## Product Change Notice

Issue Date: 27-February-2024

Smart Display AllnGaP Green and Red LED Supplier Change

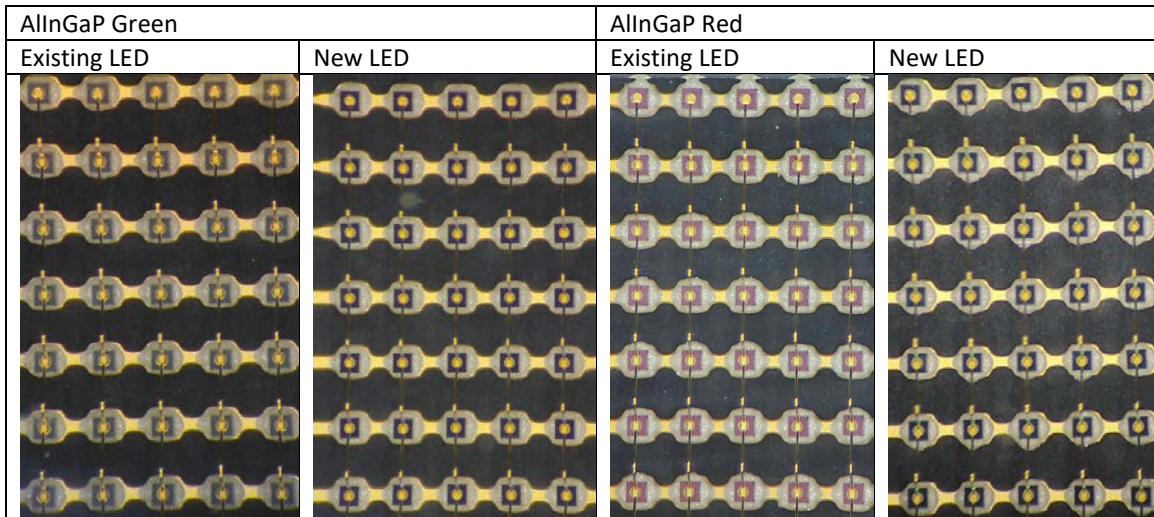
1. LED physical appearance

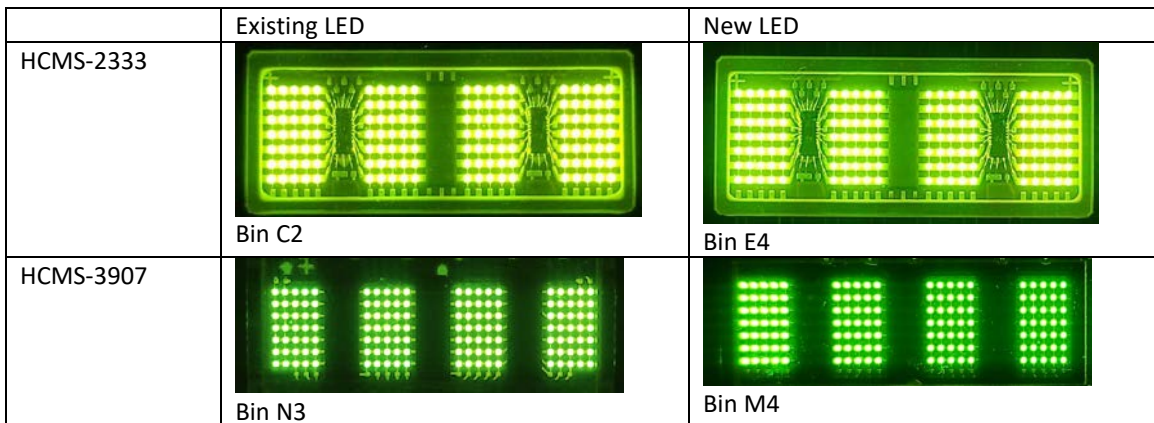
2. Iv bin shift for the AllnGaP Green

The new dice is 1-2 bins brighter compared to the existing dice
